Technical Note

Project:	P21-184 Littlestone, Kent		
Subject:	Technical Note – LLFA Response to Overland Flow Routing (Received 6 May 2022)		
Prepared by:	Lance Hammond – Project Engineer	Date:	24 May 2022
Authorised by:	Nick Fenton – Associate	Status:	S2 - Information
Document Ref:	0058-RLL-00-XX-TN-C-003	Revision:	P02

This Technical Note has been prepared by Rodgers Leask in response to the LLFA consultation response received on 6th May 2022 reference: FHDC/2021/085984.

Project: **VICTORIA ROAD WEST, LITTLESTONE, KENT**

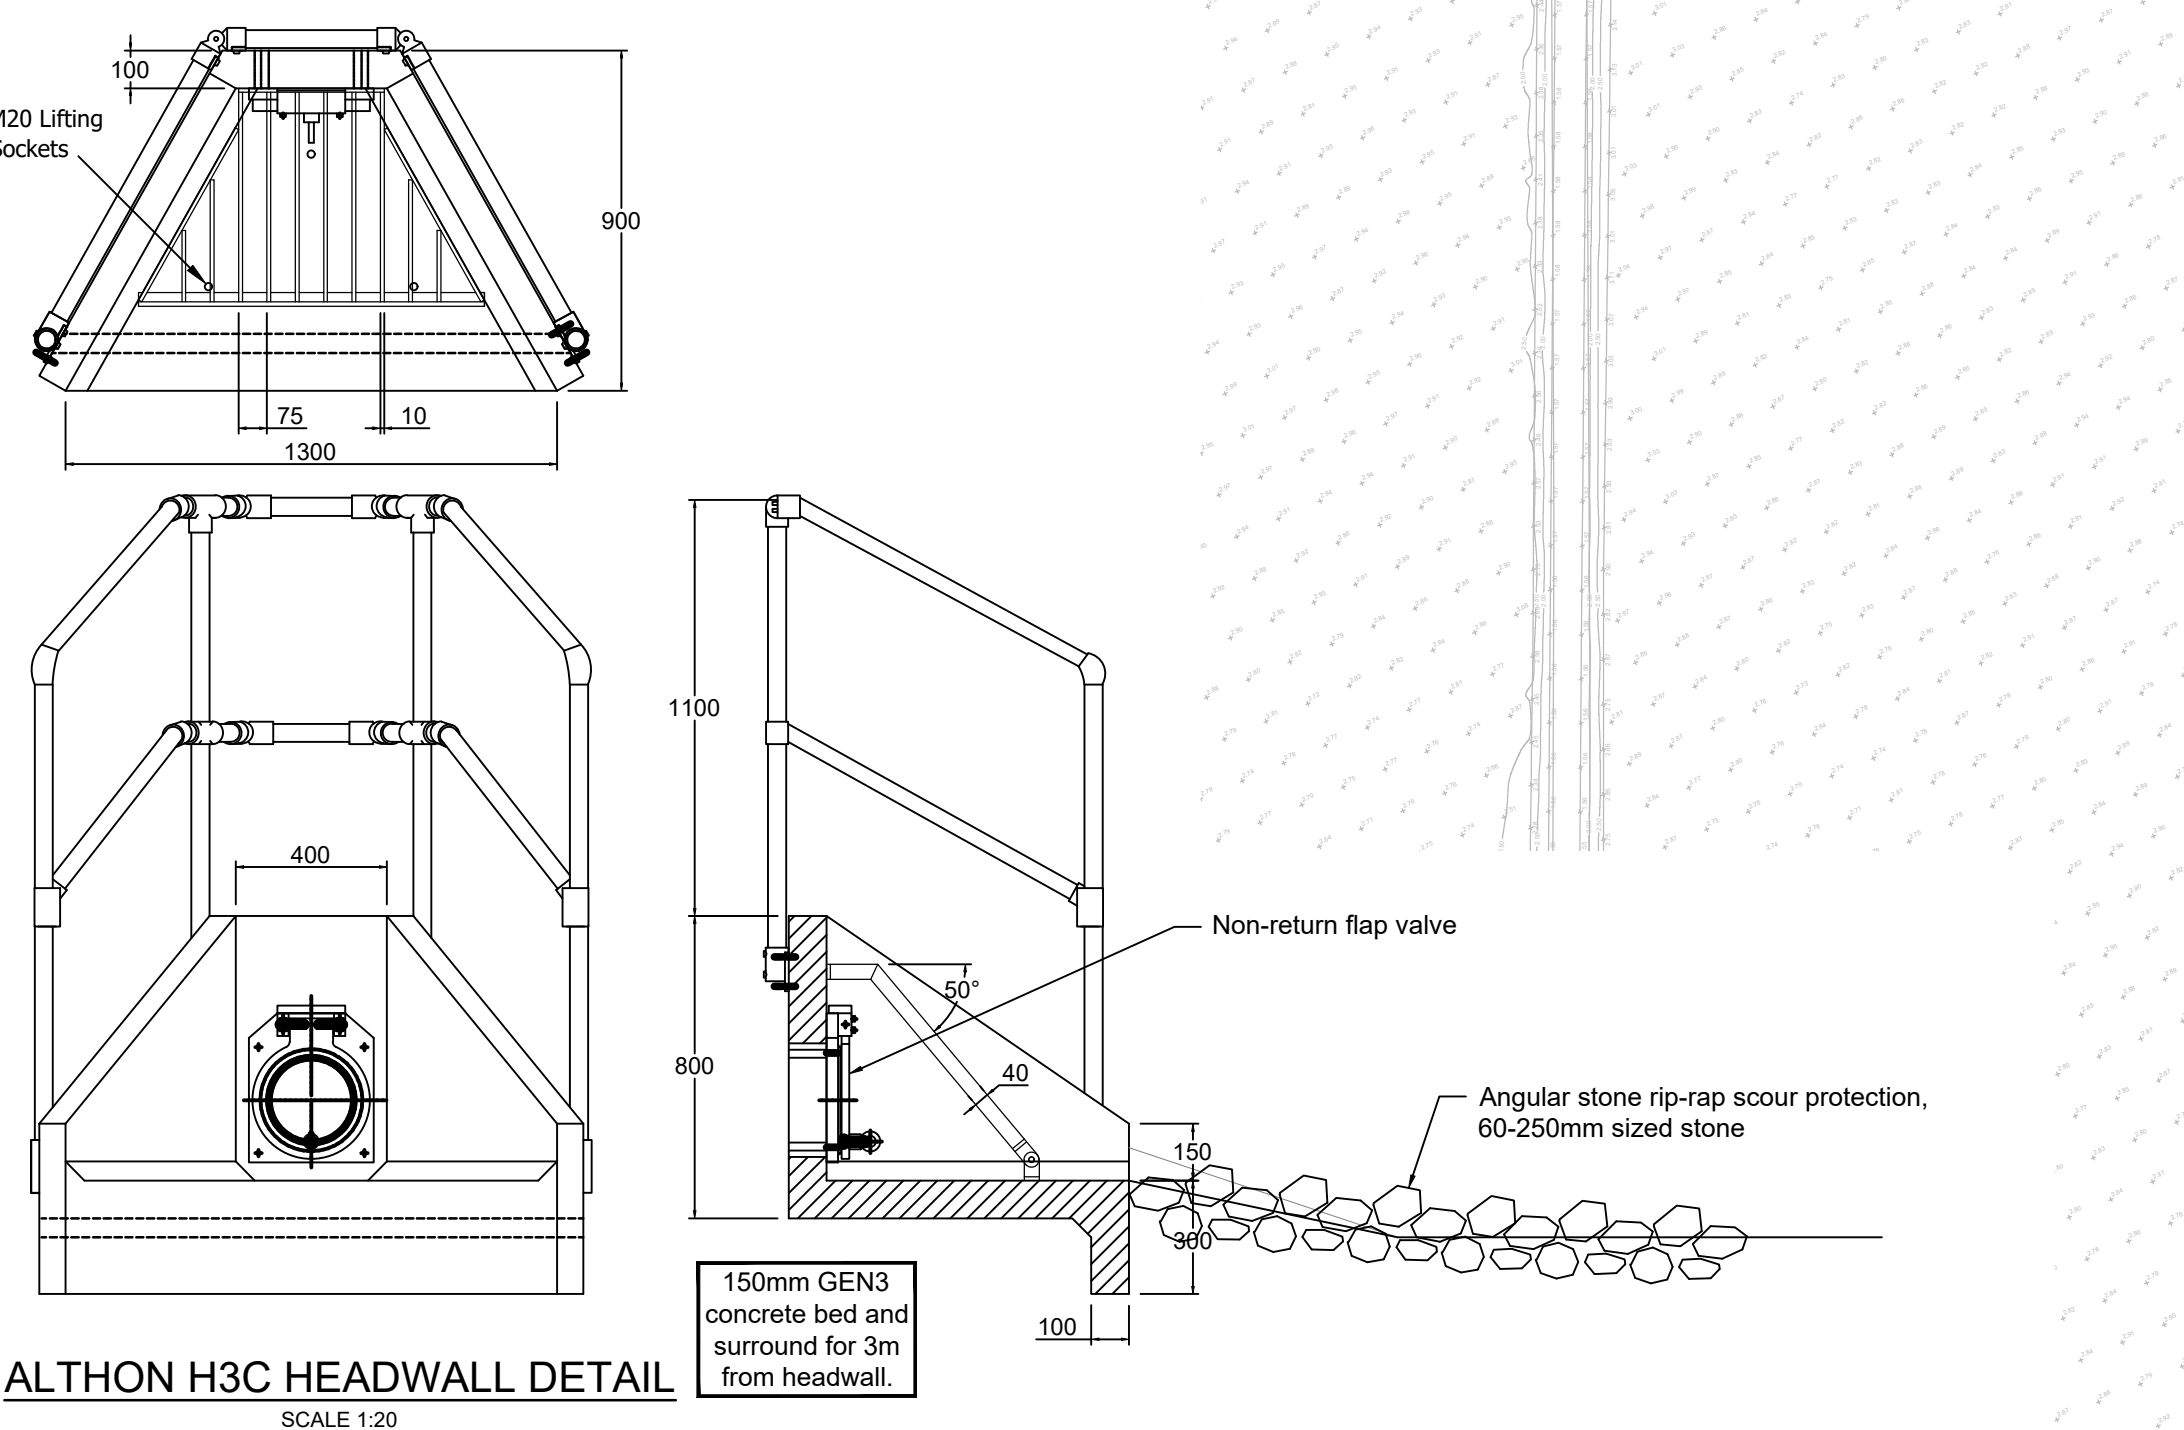
In addition to the ditch on the western side of the site, a further proposal is made regarding the possible runoff from the rear of the properties along Victoria Road and the draining of the land at this location. A 175mm perforated land drain would be installed along the northern boundary within the rear gardens of the new properties. This drain would convey any surface water into Ditch A and then be conveyed southwards.

Whilst an approach such as this is welcomed, it would be our preference for a larger gravel filled trench (minimum 300mm and inclusion of a perforated pipe) to be utilised instead. This is to improve upon overall interception and capacity of the feature. Consideration should also be applied to undertaking a catchment assessment to determine the relative contributions that would occur (overland flows), and the actual size of the trench/ drain required.

The LLFA view that any future feature positioned within these rear gardens should be managed in perpetuity. This is to protect both the existing properties along the southern side of Victoria Road and the new dwellings, to ensure appropriate land drainage. The creation of this feature also develops concern around access, infill/ removal and maintenance of the feature long term. One option for future consideration is the implementation of a restrictive covenant.

Overland Flow Routing drawing 0058-RLL-00-XX-DR-C-1015 has been updated to refine the position of the proposed land drain. The proposed land drain has been detailed to show a 225mm diameter perforated pipe within a 600mm width gravel filled trench to improve interception and capacity as requested. Modelling of overland flow from existing gardens to the rear of properties in Queens Road and rear gardens from the proposed development has been undertaken to size the land drain.

The fencing to the rear of the proposed gardens has been offset 1m to provide an access for maintenance of the feature in perpetuity. Maintenance will be undertaken by a private management company.
